RESPONSE TO REQUEST FOR ADDITIONAL INFORMATION

APR1400 Design Certification

RAI No.: 549-8856
SRP Section: 03.12 – ASME Code Class 1, 2, and 3 Piping Systems and Piping Components and Their Associated Supports
Application Section: 3.12
Date of RAI Issue: 07/07/2017

Question No. 03.12-19

Figure 2-1. Dimensions of Discharge Tube Used in Palde's Experiment

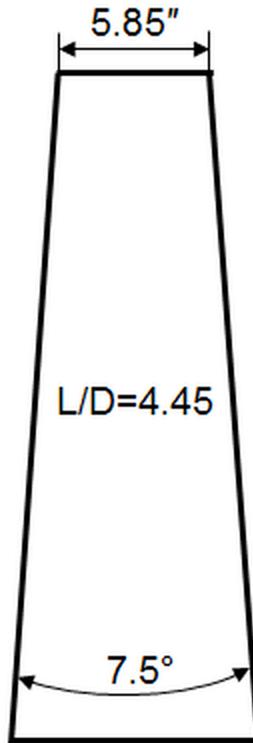
- a) The staff would like to understand whether and how cavitation effects and vibration originating from the operation of the SIT and its FD have been taken in to account in the structural design evaluation of the SIT, its discharge piping and pipe supports.
- b) Also please discuss whether the operation of the SIT with its FD can result in other phenomena, such as water hammer, and how their effects have been accounted for in the structural design of SIT, FD, piping and supports.
- c) In addition, please discuss whether the structural evaluation model of the SIT is coupled with the FD. If decoupled, please discuss how consideration for protection against resonance has been accounted for.

In order to assess the possibility of resonance caused by vortex breakdown, the CFD analysis results were compared with Palde's draft tube experiments [6]. Palde tested 75 distinct tube shapes. Most of them were simple geometrical shapes or combinations of straight circular cylinders, truncated diverging cones, and circular cross-sectional elbows. However, it is determined that there is not an identical shape corresponding to the fluidic device discharge nozzle in Palde's tests. Therefore, the most approximate shape in the Palde's tests is used to estimate the frequency parameter. Figures 2-1 to 2-3 show the dimensions of the fluidic device compared to Palde's discharge tubes.
